STAFF REPORT

Community Planning and Preservation Commission
Certificate of Appropriateness Request

Case No.: 22-90200099

REQUEST: Review of a Certificate of Appropriateness application for the replacement of 15 historic wood sash, picture, and casement, and non-historic aluminum awning windows with vinyl single-hung sash and horizontal sliding windows in existing openings

Figure 4: Example of the historic sash windows original to 3150 7th Ave N. Image from the City of Anaheim's "Architectural Style Guide: Minimal Traditional."

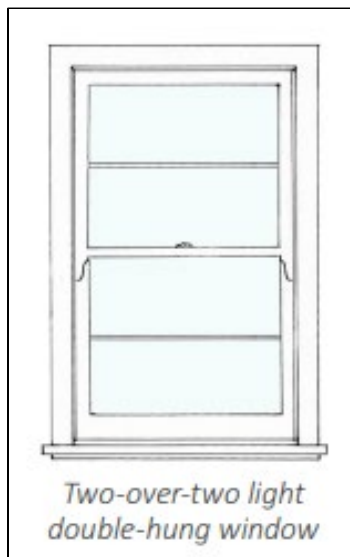
The proposed windows are a different material than extant or original windows (vinyl is proposed to replace the original wood windows and the not approved aluminum windows), but the operation will be retained in the case of the sash windows.

The proposed windows feature three-over-one sash and horizontal sliding configurations. This is a change from existing/historic configurations at the subject property, and not compatible with the building's transitional Minimal Traditional/post-War vernacular architectural style.

1. Windows will be installed to be setback within the wall plane and feature a reveal of at least two inches, to match the historic window reveal.
2. Windows will be feature external, three-dimensional contoured grilles to replicate traditional muntins, and the muntin pattern will replicate the two-over-two horizontal oriented sash configuration, and picture window with sidelights configuration where applicable, as depicted in this staff report.
3. A historic preservation final inspection will be required.
4. All other necessary permits shall be obtained. Any additional work shall be presented to staff for determination of the necessity of additional COA approval.
5. This approval will be valid for 24 months from the date of this hearing, with an expiration date of November 8, 2024.

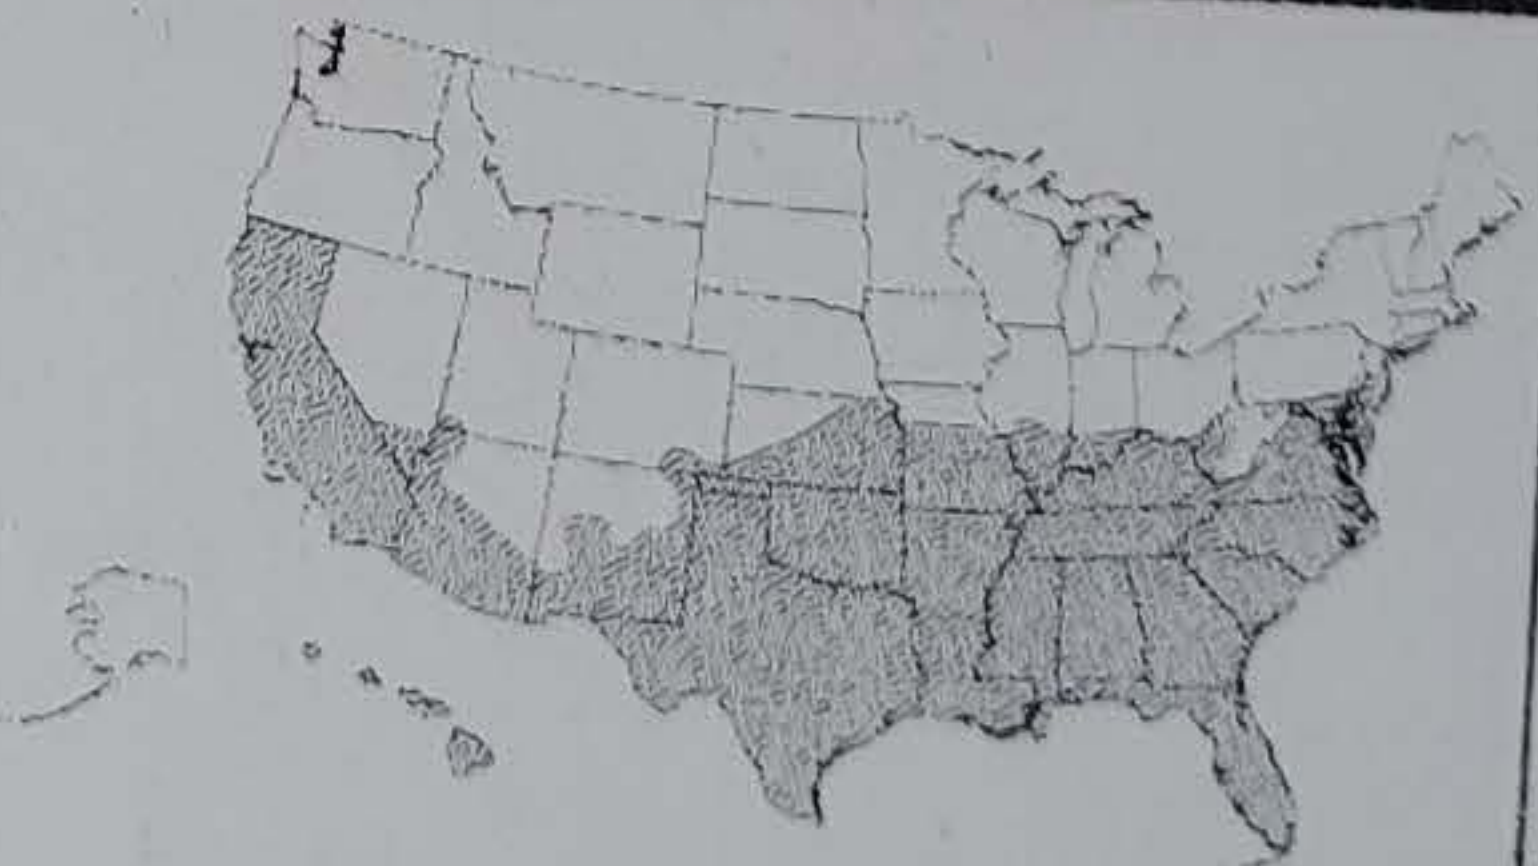
The photograph submitted of the proposed horizontal sliding window shows the brand ViWinTech. These windows do not appear to be impact resistant based on staff research.
